N400NAS4

TECHNICAL BULLETIN

Service Action: Startup Battery Ground Stud - Insufficient Ground Contact

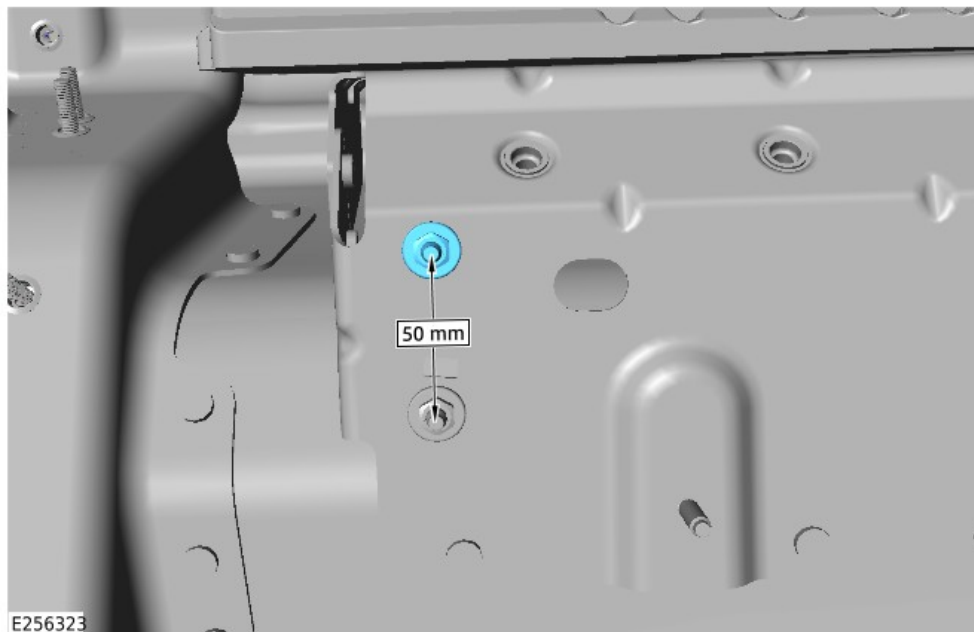
4.

Remove the startup battery ground cable from the body ground stud (G4D178).

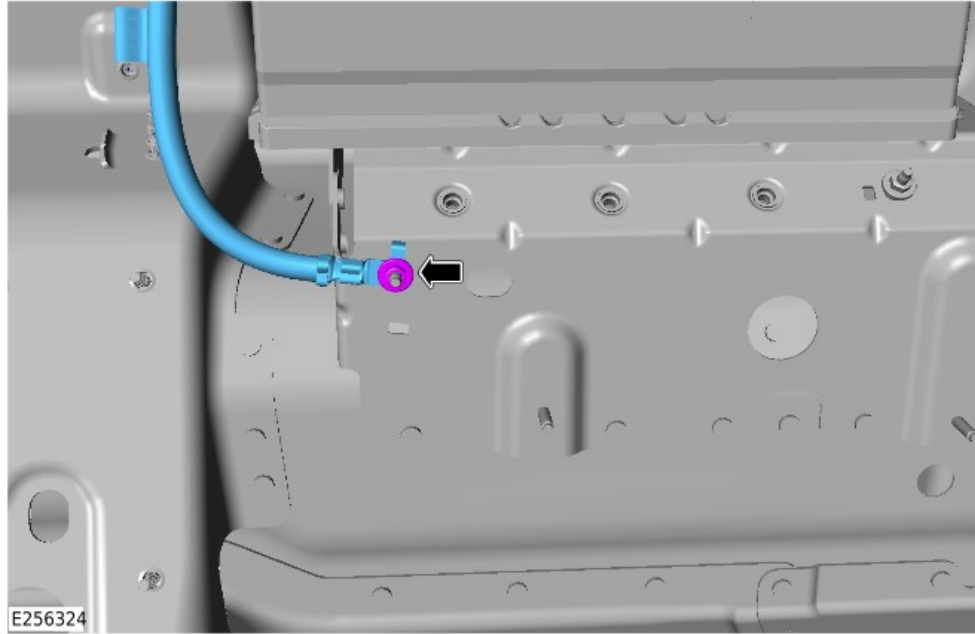
5.

Install a new body ground stud (78905) 50 mm above the existing ground stud (G4D178) (see TOPIx Workshop Manual section 501-25A: Body Repairs General Information - General Procedures - Body Earth Stud Repair).

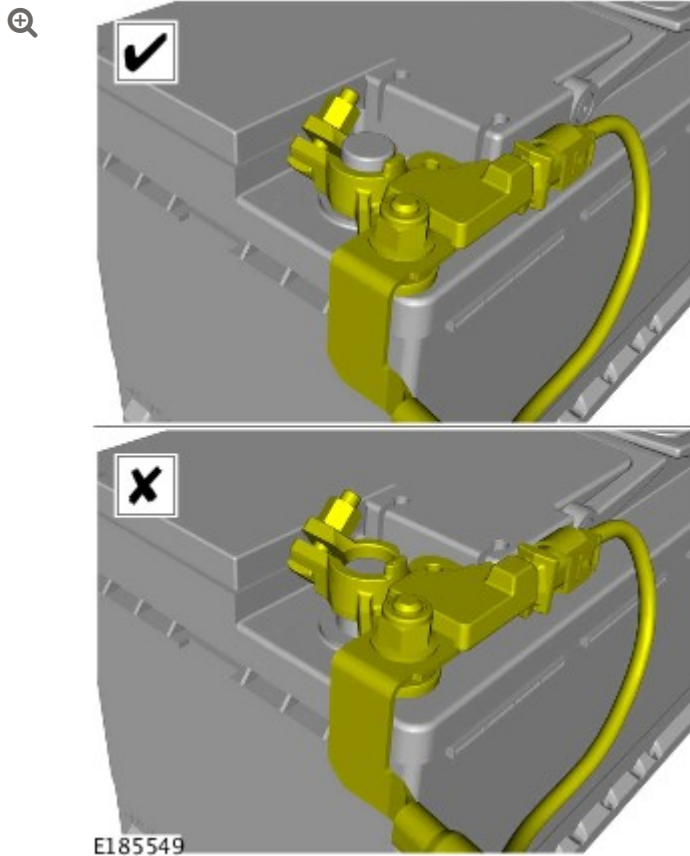
6. ■

Install the startup battery ground cable to the new body ground stud.

- Torque: **8 Nm**

Make sure the battery terminal is in the correct position.
